Meeting Agenda

Historic Zoning Commission

Monday, November 14, 2022

Site Plan

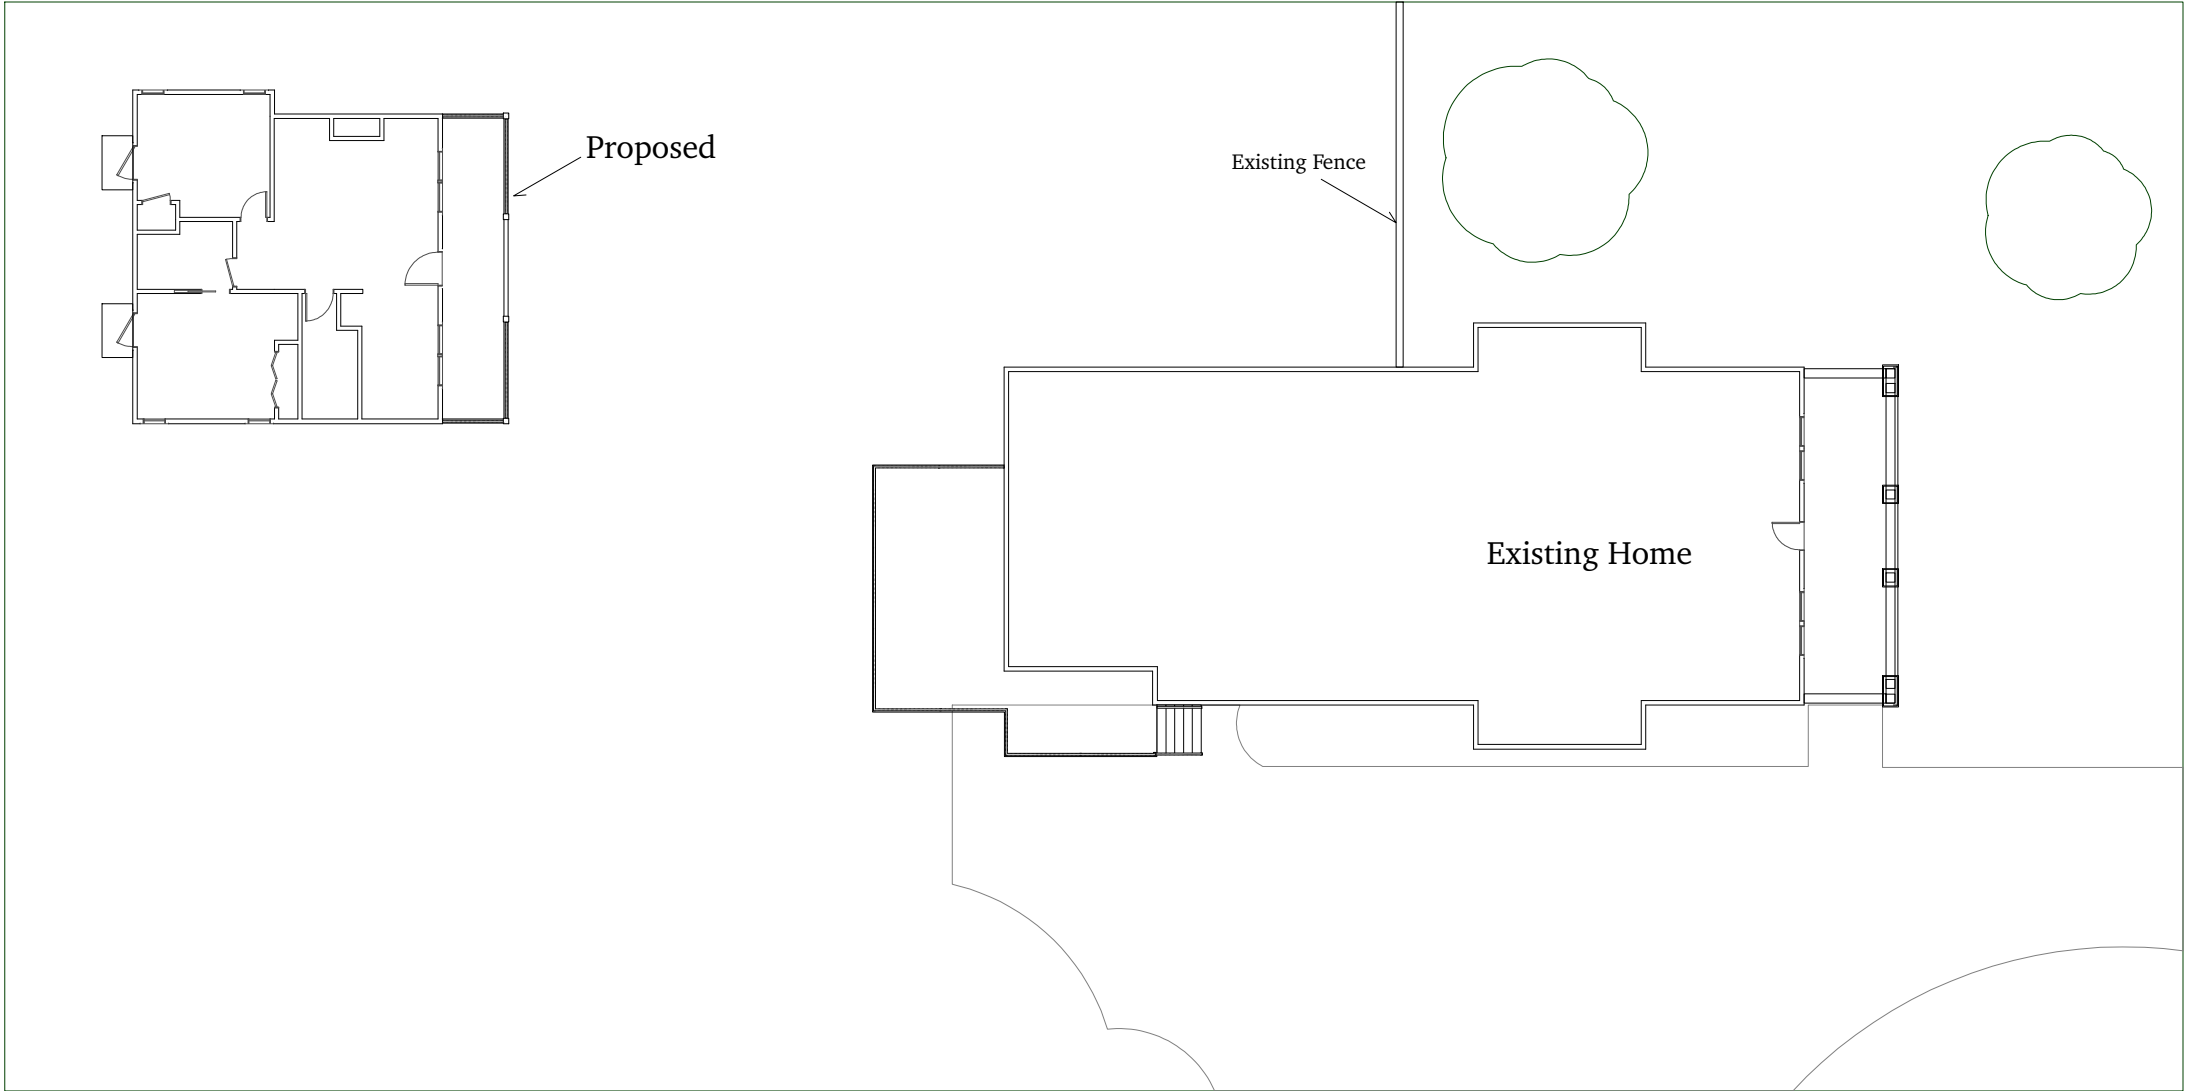
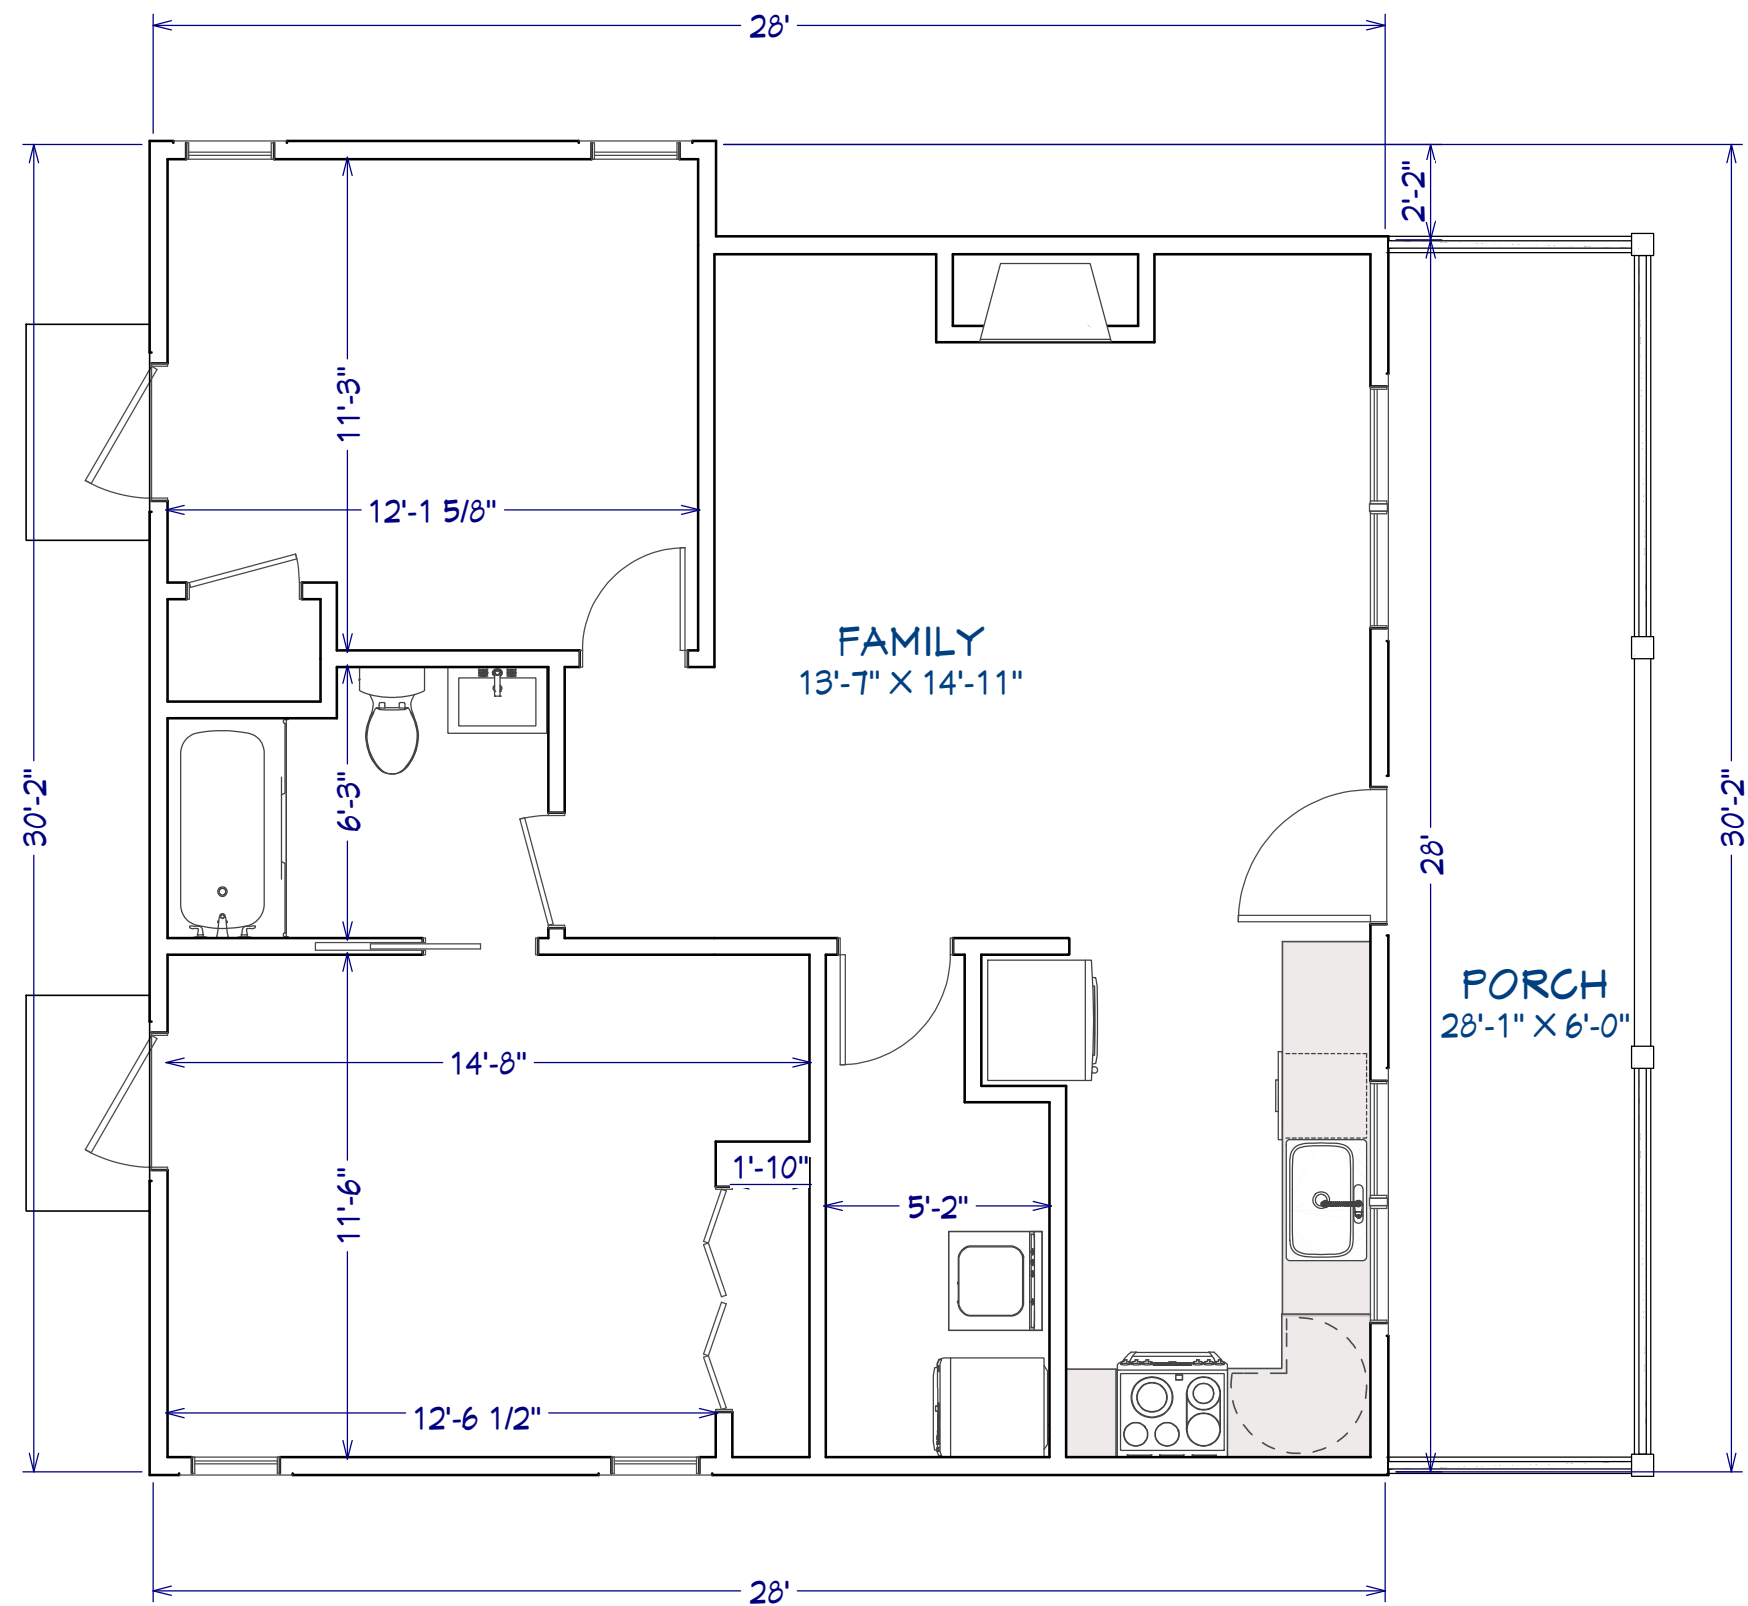
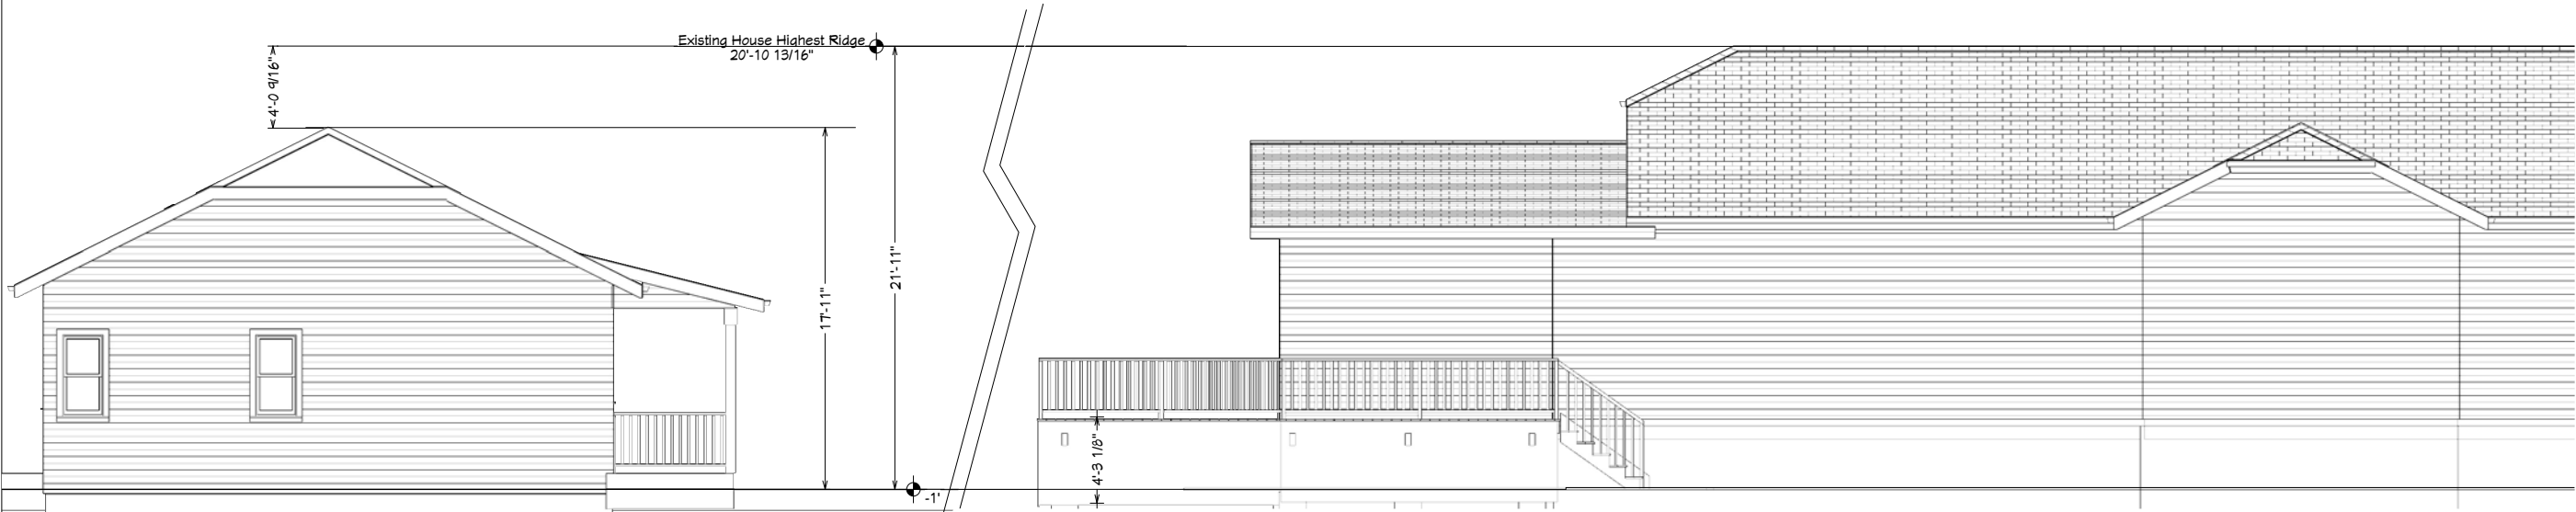
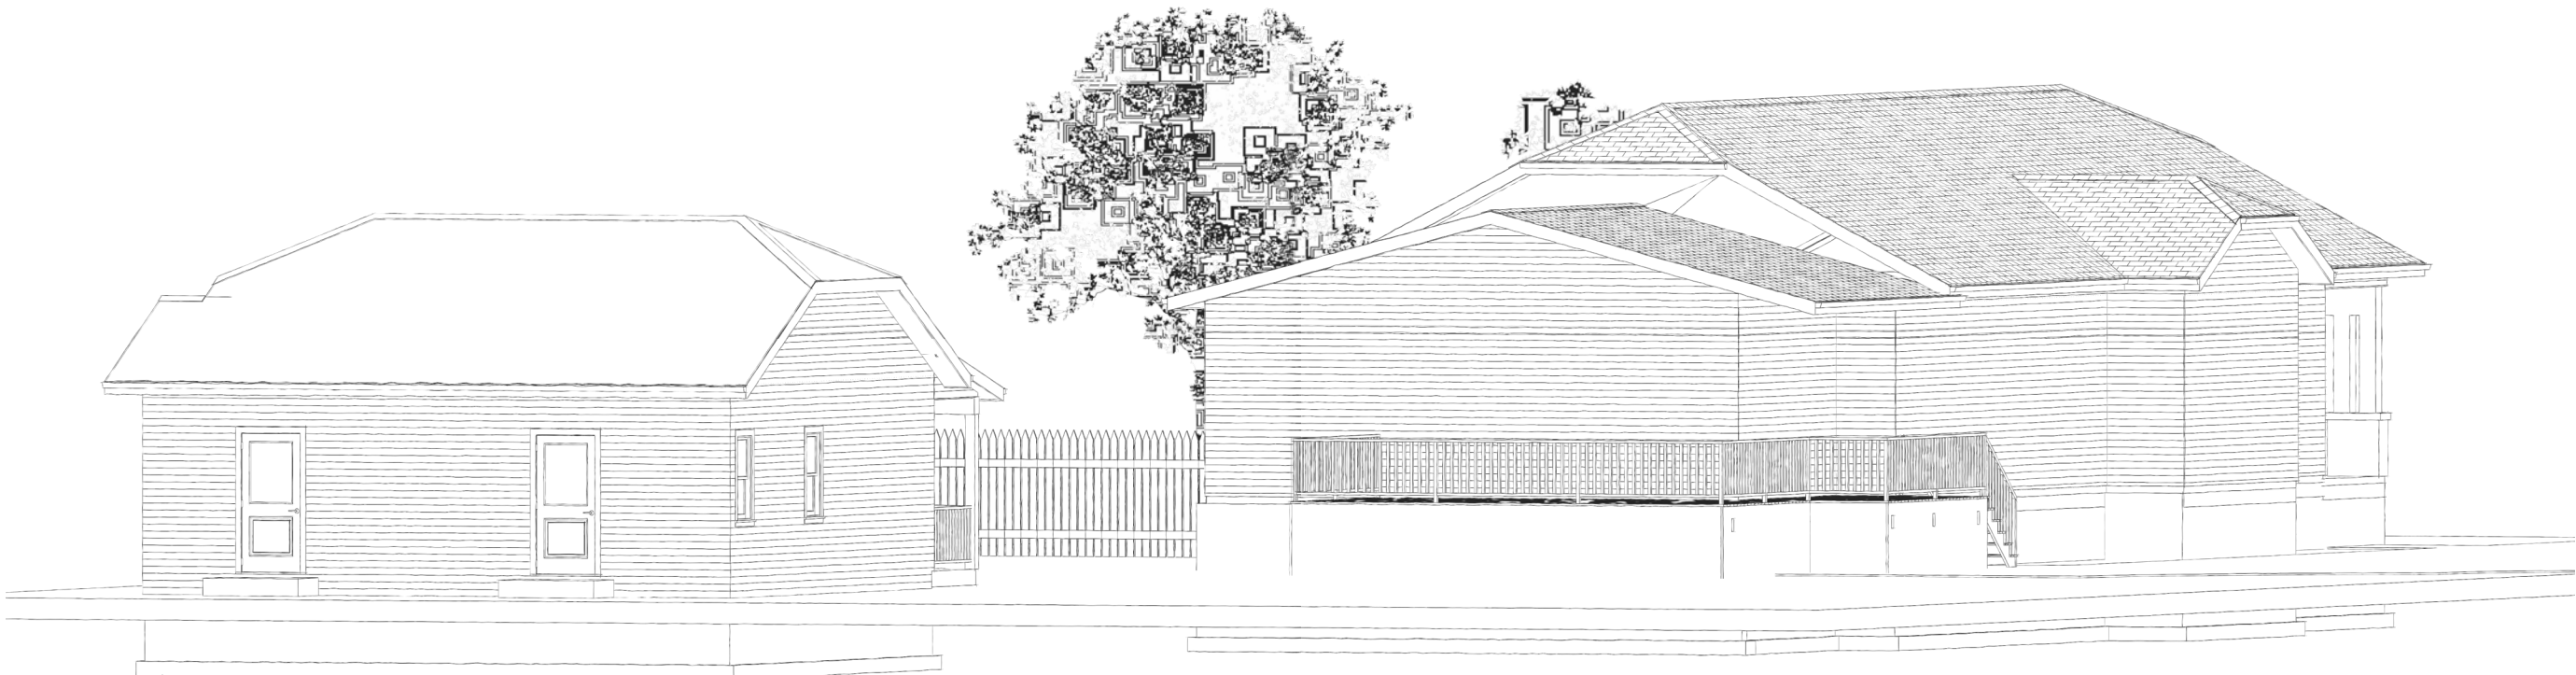
- **Details & Ornamentation:** Details complement, but are less elaborate than, the character of the historic building. The roof form relates to the pitch and shape of the principal building. At the staff and the DRC's recommendation, the original design has been modified to remove a full-width front porch. Instead, the proposal includes a bracketed covered entrance.

2. The right elevation is missing from the COA application. If issued a COA, the applicant must provide the right elevation to the Preservation Planner so it may be reviewed in light of the applicable Guidelines. The right elevation must be approved by the Preservation Planner prior to issuance of a building permit.

3. If issued a COA, the accessory structure windows must have historic profile and dimension and consist of either wood or a composite material with the appearance of wood; the exact window specifications must be approved by the Preservation Planner or the HZC prior to issuance of a building permit.

4. If issued a COA, the application must meet all the requirements of the Building & Neighborhood Services Department prior to issuance of a building permit, and any additional changes to the approved plans must be returned to the Preservation Planner or the Historic Zoning Commission for review and approval.
